ADDENDUM NO. 1

DEERFIELD
Federal Aid Project No. BFL(BR-OFF)-0032(052)X
Bridge Replacement, D-06-001,
Upper Road Over Deerfield River

Transmitting revisions to the Contract Documents as follows:

Revised Plan Sheets 47, 49, 50, 51, 52, 61 & 63 of 92.

SCALE: 3/8" = 1'-0"

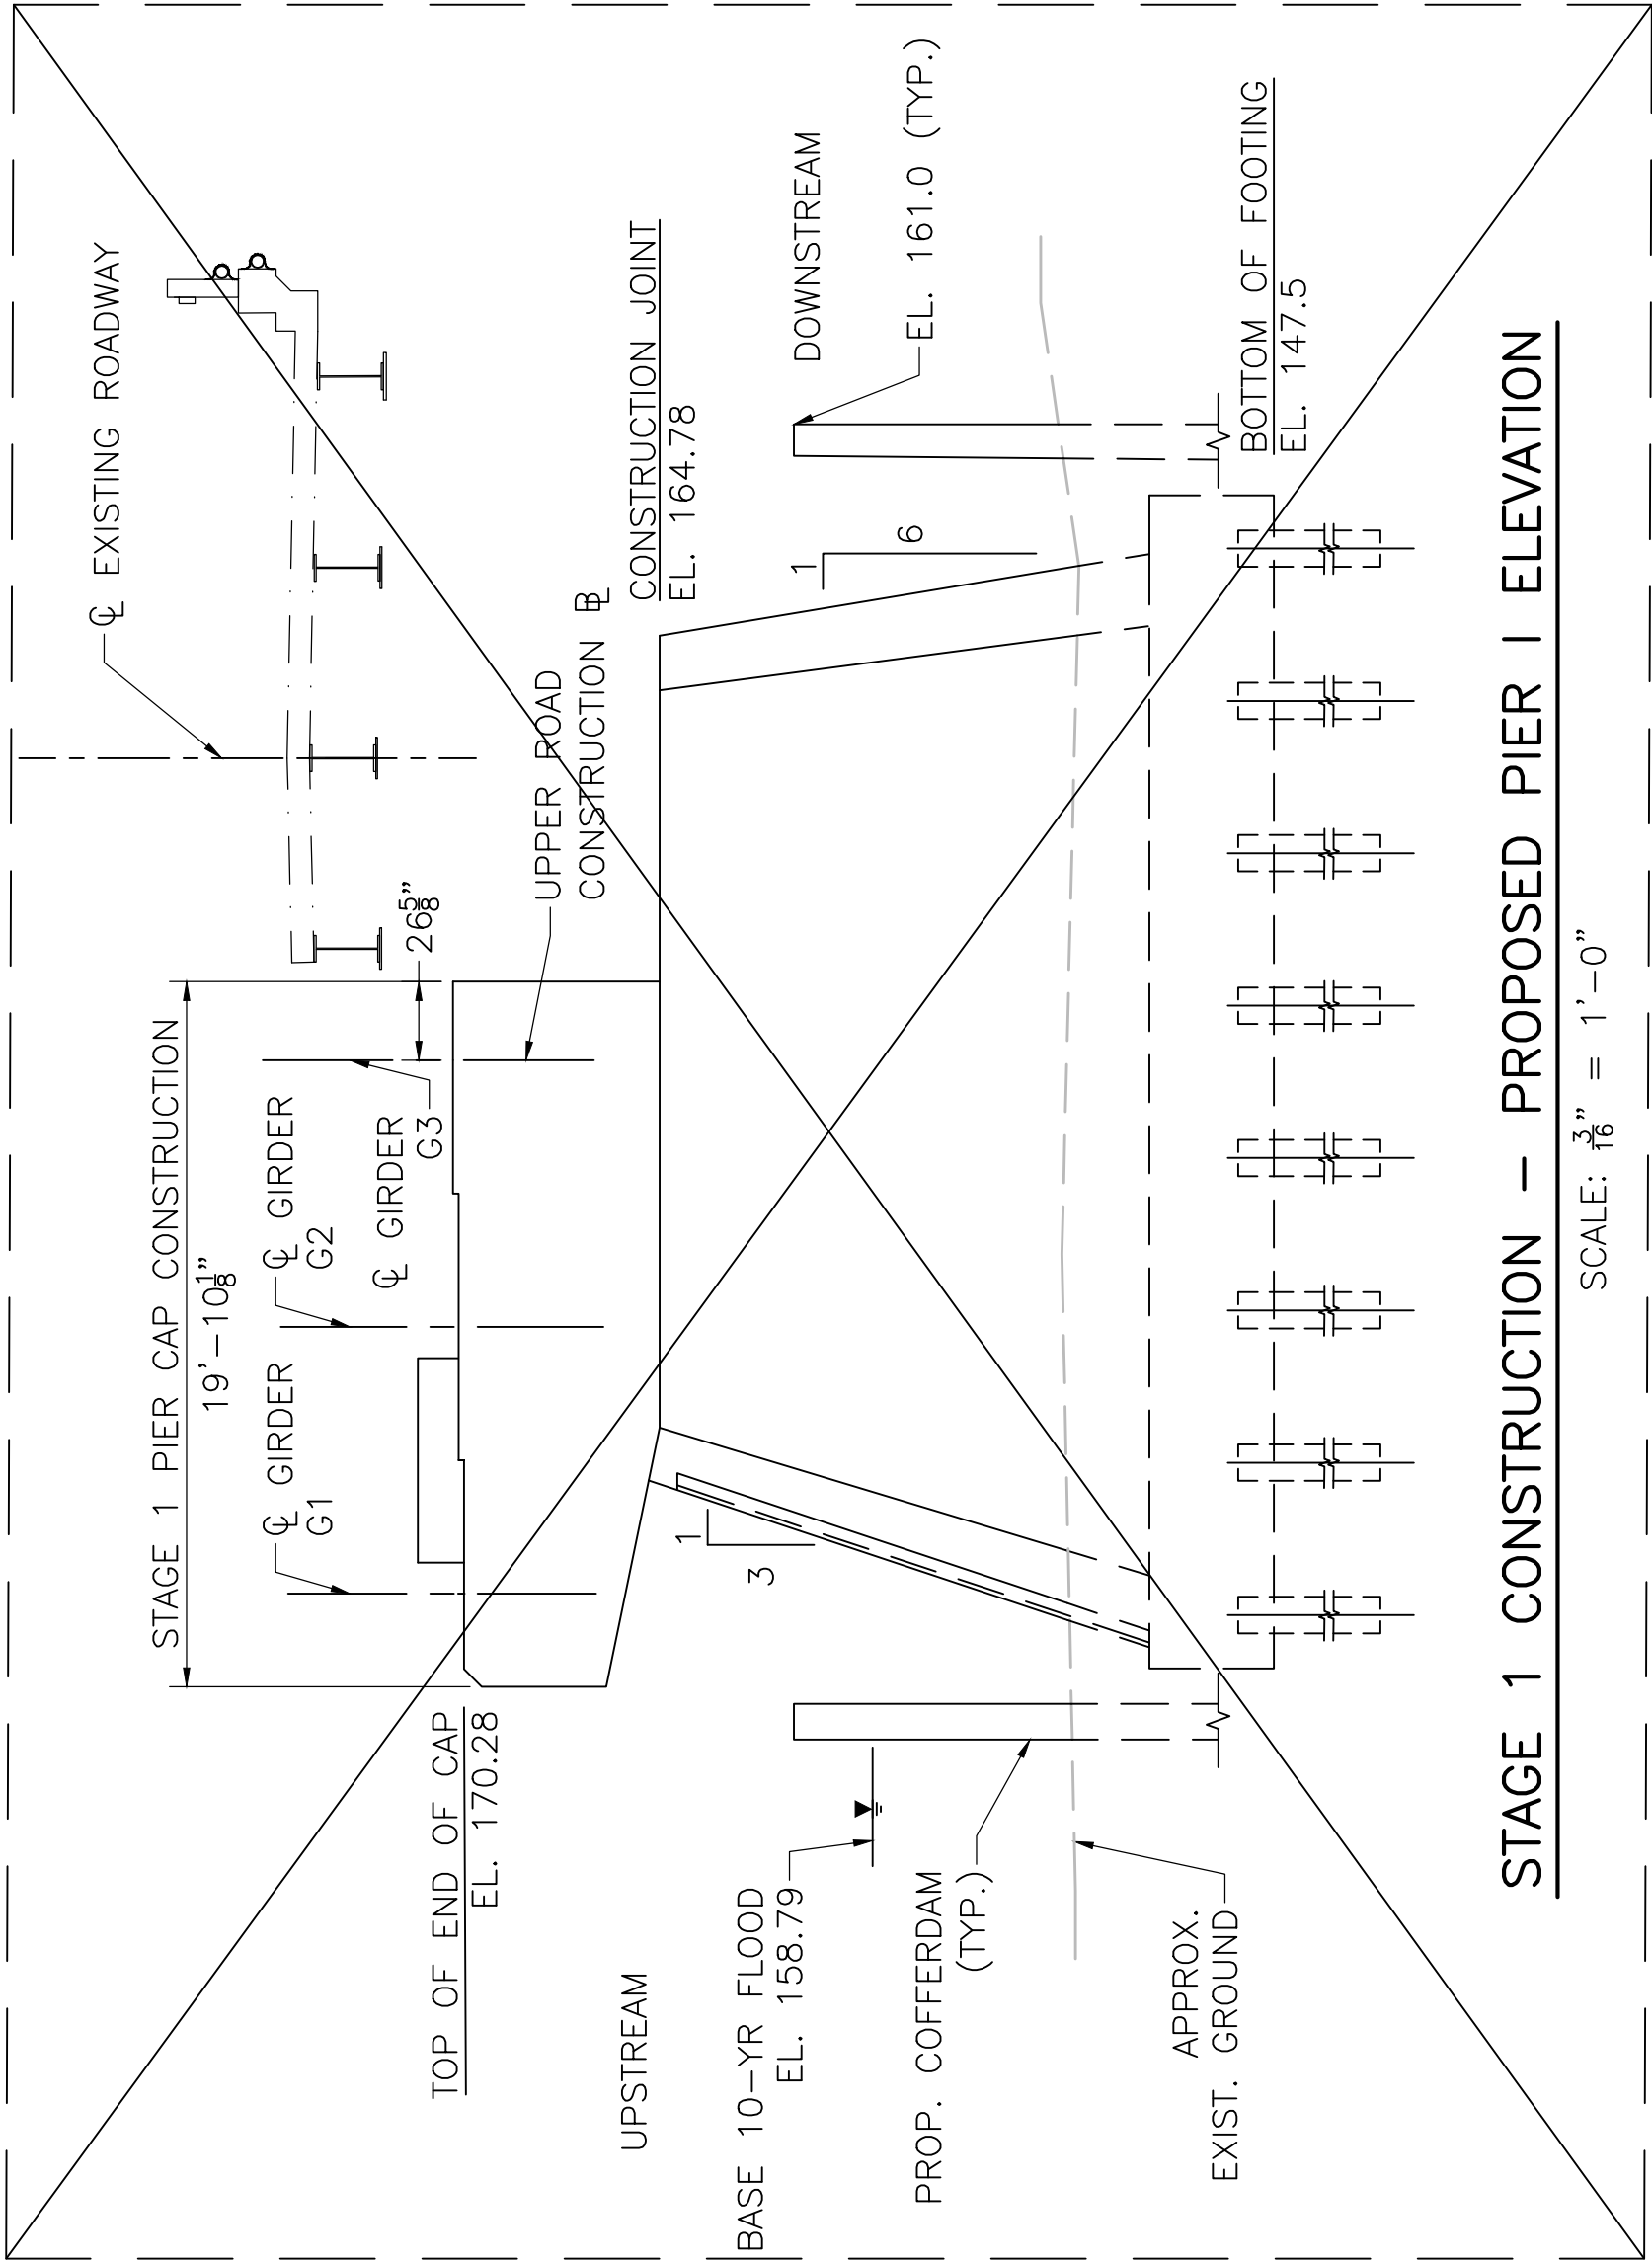
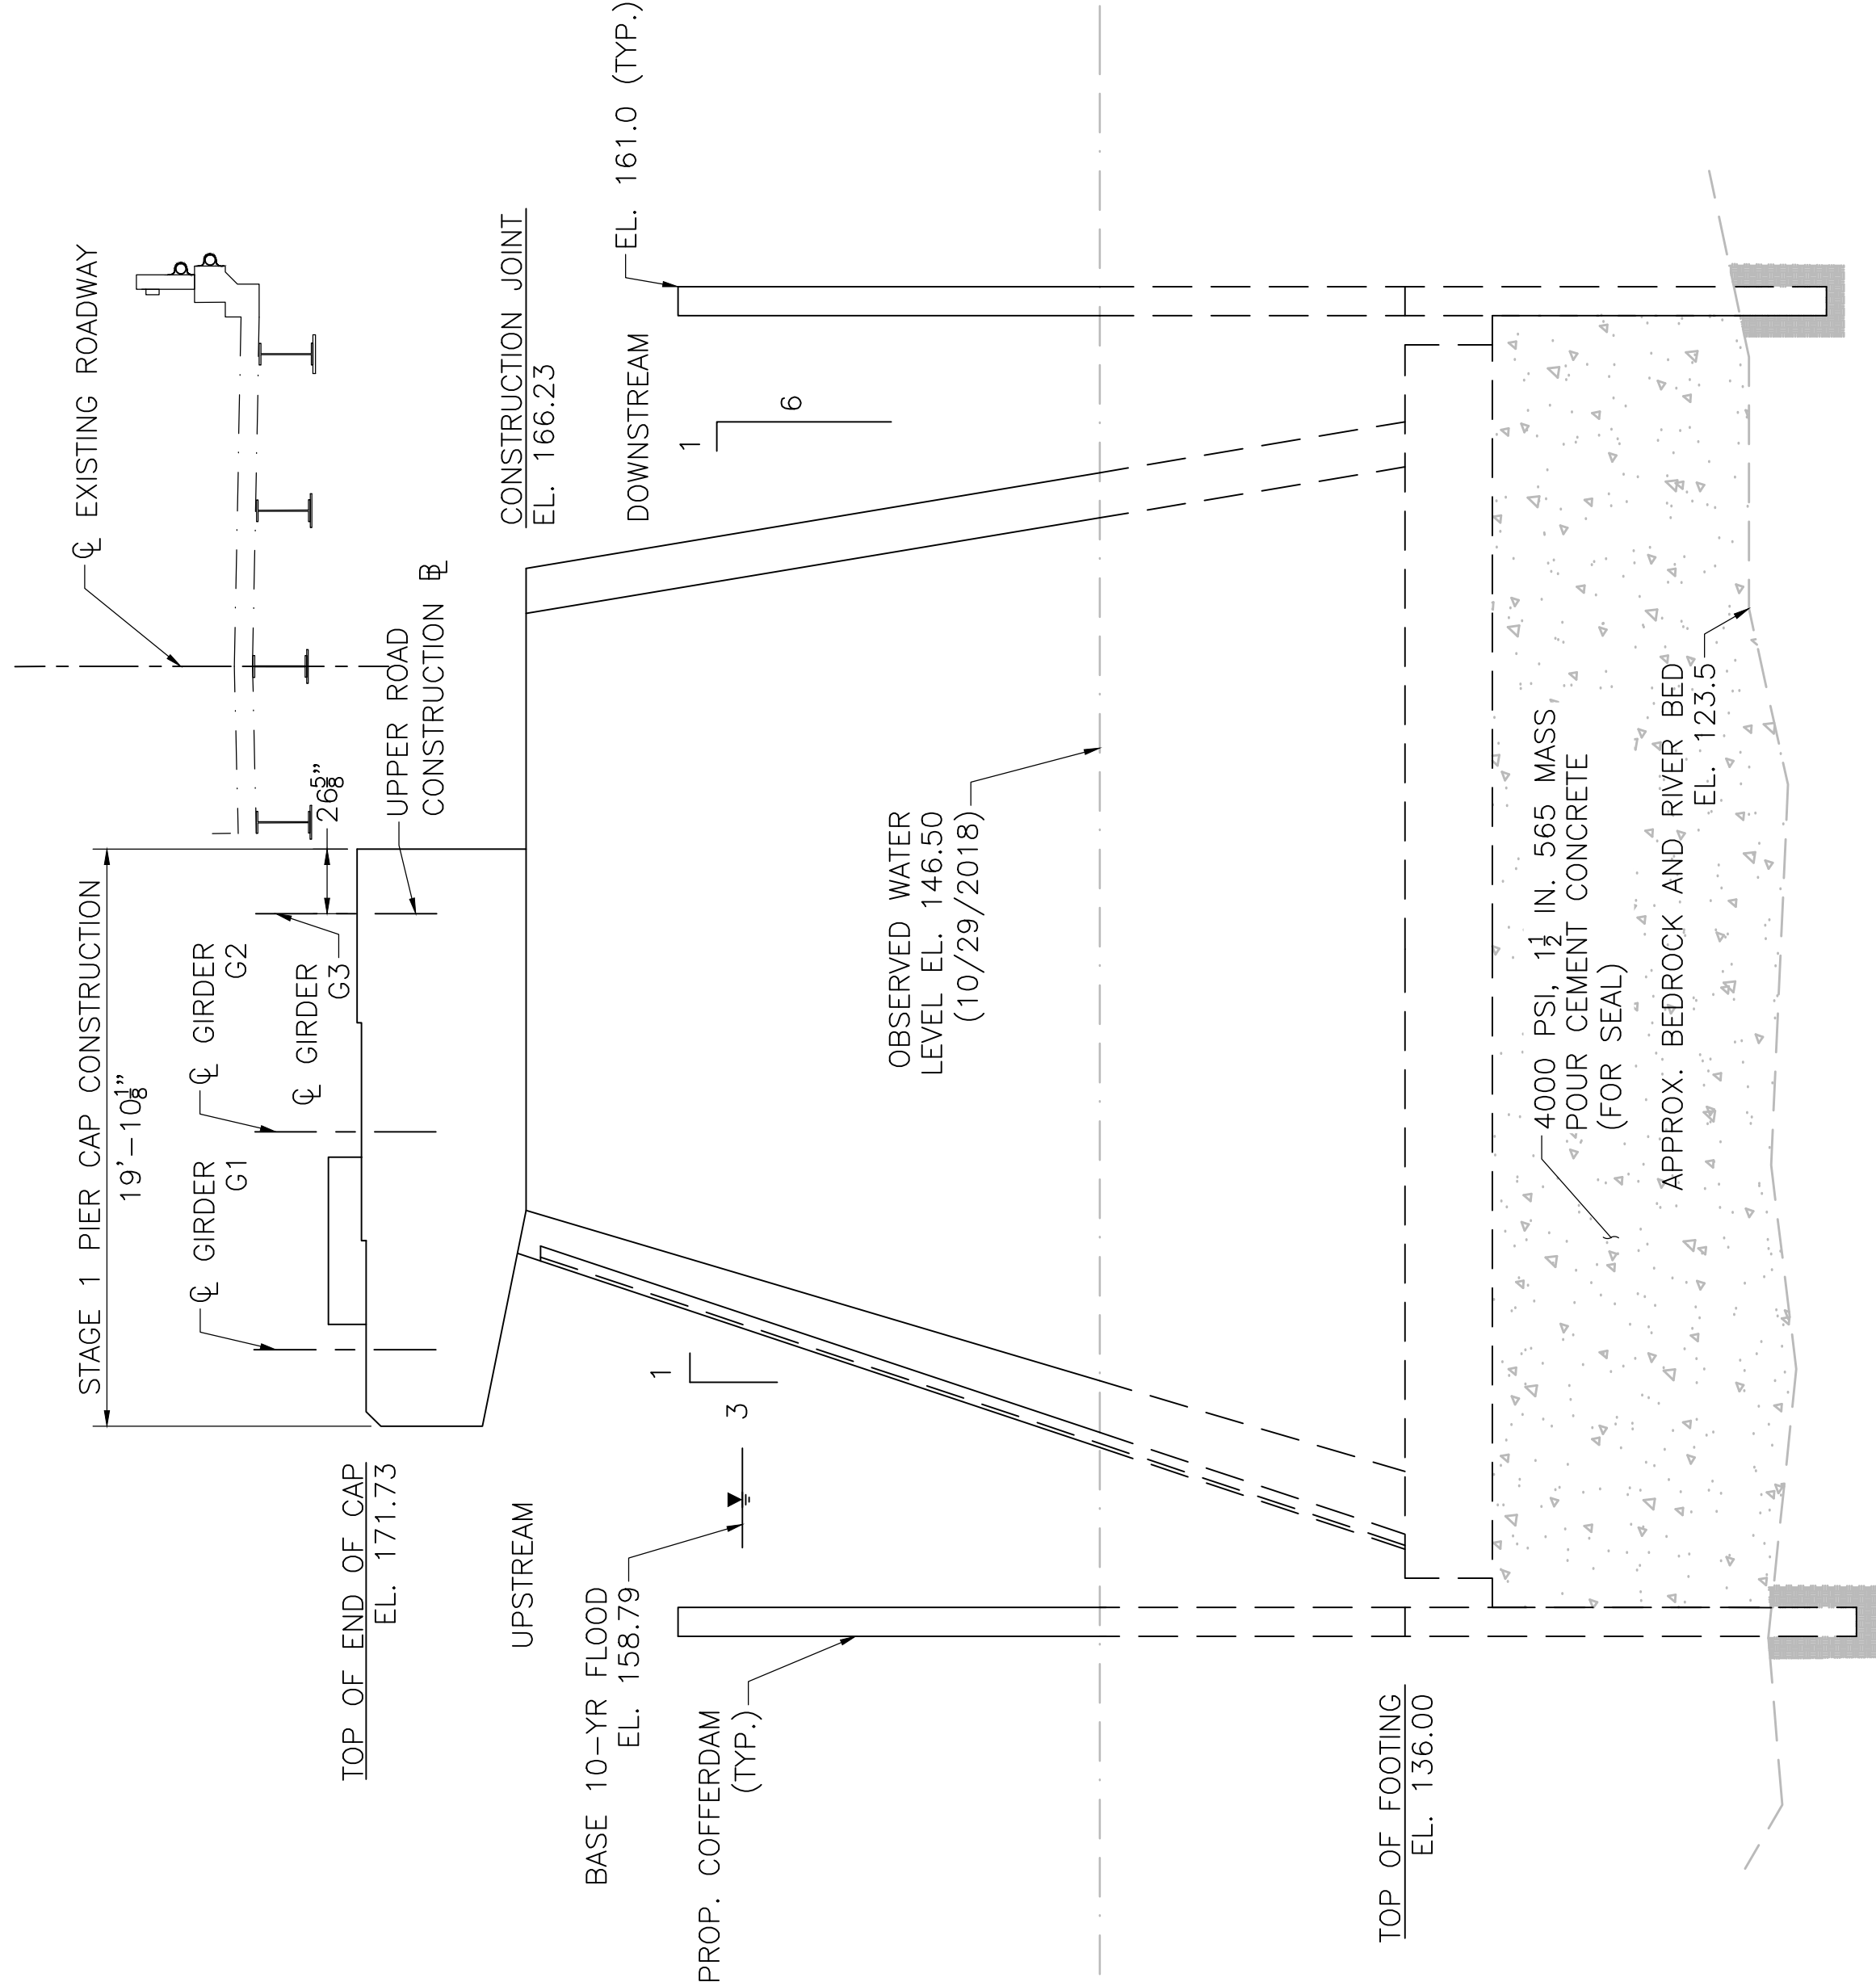
The proposed Pier 1 shows 24 H-piles driven to a tip elevation of 61.5, each pile with a length in excess of 85 feet. All 24 piles are shown to be installed in Stage 1, and it appears that approximately half of these piles are shown to be installed under the remaining portion of the existing bridge deck (Bridge Drawings, Sheet 13 of 41 Sheets). If this is the intent, then the piles to be installed with limited overhead room may not be able to be installed in accordance with the Standard Specifications for Subsection 940: Driven Piles, in regards to pile lengths, use of fixed leads on a crane, etc.

Can Pier 1 be installed and built with construction joints in the footing and stem for the phased construction approach, like what is shown for construction joints in the south abutment?

1 SEE REVISED DETAIL, THIS SHEET.

See revised Plan Sheets 47 of 92 (11 of 41), 49 of 92 (13 of 41), 50 of 92 (14 of 41), 52 of 92 (16 of 41), 61 of 92 (25 of 41), and 63 of 92 (27 of 41) issued via this addendum.
